Project	<b>IEEE 802.16 Broadband Wireless Access Working Group</b> < <a href="http://ieee802.org/16">http://ieee802.org/16</a> >
Title	Limitations on ranging/BW-req allocations needed to maintain slot structure
Date Submitted	<b>2004-08-18</b>
Source(s)	Intel.  Yuval Lomnitz <a href="mailto:Yuval.Lomnitz@intel.com">Yuval.Lomnitz@intel.com</a>  Yigal Eliaşpur <a href="mailto:Yigal.Eliaspur@intel.com">Yigal.Eliaspur@intel.com</a>  Dov Andelman
Re:	IEEE P802.16REVd/D5-2004
Abstract	Define limitations on ranging/BW req allocations so that basic tile structure in the uplink is not broken.
Purpose	Adopt changes
Notice	This document has been prepared to assist IEEE 802.16. It is offered as a basis for discussion and is not binding on the contributing individual(s) or organization(s). The material in this document is subject to change in form and content after further study. The contributor(s) reserve(s) the right to add, amend or withdraw material contained herein.

# Limitations on ranging/BW-req allocations needed to maintain slot structure

Figure XXX: example of UIUC=12,13 allocation rules.

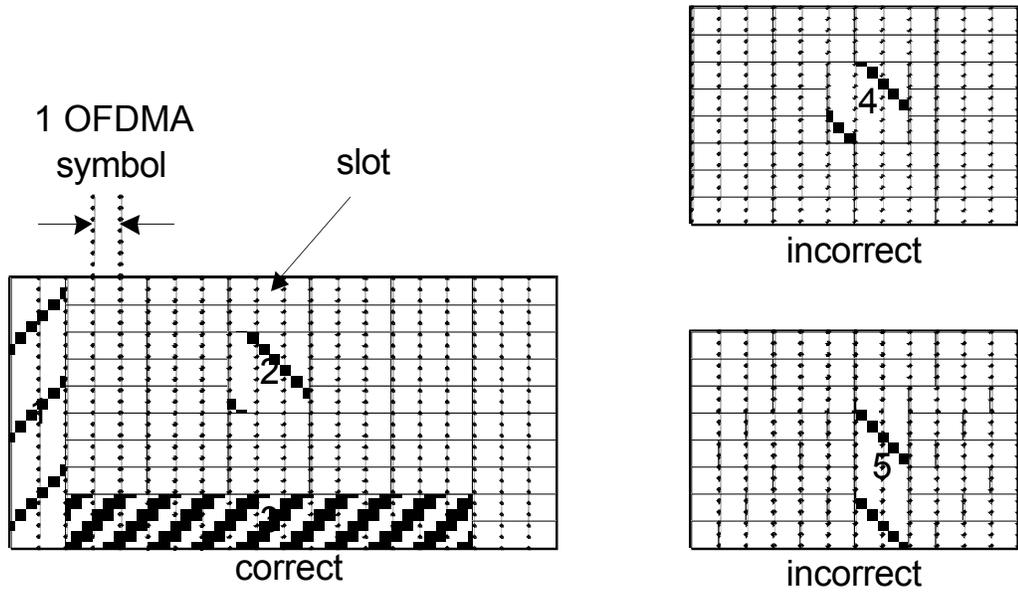
The following figure depicts correct and incorrect allocations of UIUC=12,13 regions. Each rectangle is an UL-subframe (or zone). Regions 1,2,3 are correct allocations, and 4,5 are incorrect allocations.

Rectangular allocations made with UIUC=12,13 (ranging and BW-request) shall not break the UL tile structure, and conform to the following rules:

1. In each subchannel, the size of each continuous group of OFDMA symbols remaining after allocation of UIUC=12,13 regions shall be a multiple of 3 OFDMA symbols.
2. The slot boundaries in all subchannels shall be aligned, i.e. if a slot starts in symbol  $k$  in any subchannel, then no slots are allowed to start at symbols  $k+1$ ,  $k+2$  at any other subchannel.
